4982A-11

S E R V I C E N O T E

HP 4982A Network Advisor

Monochrome LED Board Modification (NOT Color)

J2176-66502 LED Board Assembly

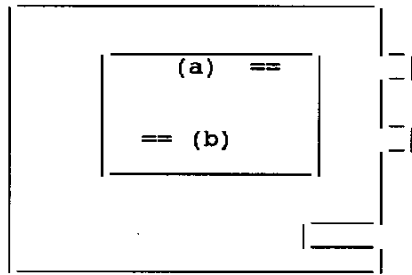
When new monochrome assembly 5063-1880 is required to replace the older 5062-9677 display, the LED board must be modified. The modification will allow a greater range of brightness adjustment.

1. Remove fastener(s)
2. Disconnect jumper wires

3. Carefully snap out LED display board assembly
4. Locate jumper and remove at one of either location as shown in the diagram

Jumper locations
(a) or (b) is on
the small board.

5. Reinstall wires/fasteners and board assembly
6. Test brightness operation
